DUNE PDR: Cold Electronics WIB and System

Questions / comments received from the committee on Wednesday 25 March. The answers from the TPC electronics consortium are clearly marked in *italic*.

WIEC

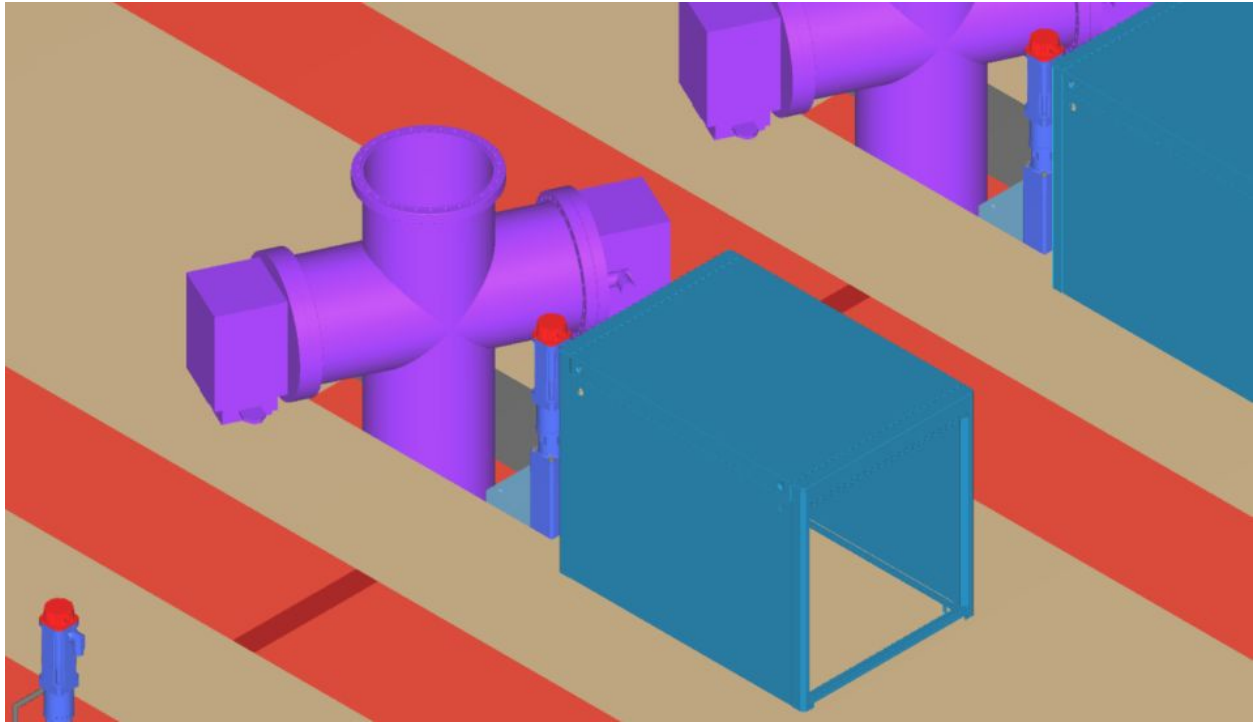
How accessible are the warm flanges for regular maintenance of the air filters?

The warm flanges are easily accessible on the top of the cryostat, and we do not think that the maintenance of the air filters (i.e. replacing the old filter with a new one) will require more than a few minutes of down time for each WIEC. The following picture shows the spool piece (the cross) attached to the TPC electronics cryostat penetration (in purple) with the two WIECs and the PD flange (only one of the WIECs is clearly visible), installed closely to a photon detector system mini-rack (in blue). The ribs of the cryostat support structure are shown in red and the false flooring installed on the top of cryostat is shown in light brown. The WIECs are at a height

of ~20 cms above the false flooring, which means that the personnel replacing the air filters will have to kneel or bend over during the operation. The area on top of the cryostat will be accessible without any restriction during the operation of the detector (we actually have to plan for a fence around the TPC electronics cryostat penetrations and the photon detector mini-racks to prevent people from running into them). It should be noted that in this drawing the filter is at the bottom of the WIEC, with the air flowing upward. Given the small distance between the WIEC and the false floor it has been decided to put the air filter above the WIEC and have the air flowing downward. This change has yet to be propagated in the CAD models

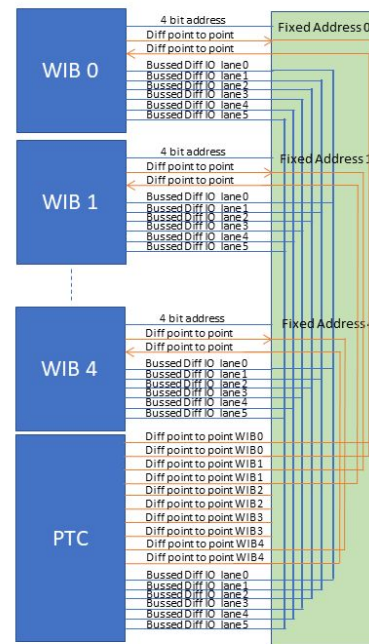
Is there a plan to have a complete working feed-through assembly including WIEC (aside from the ProtoDUNE detector) for testing and long-term maintenance?

For firmware development purposes we will have multiple WIECs operating. These may not be fully populated (i.e. have multiple WIBs), but the goal is to have one of them operating in each institution involved with the WIB/PTC firmware development. Eventually, during operations, we could think about having one of these test stands on the surface at SURF, in such a way that the personnel responsible for operation on site will be able to exercise the maintenance tasks there, prior to performing them on the systems used for data taking.
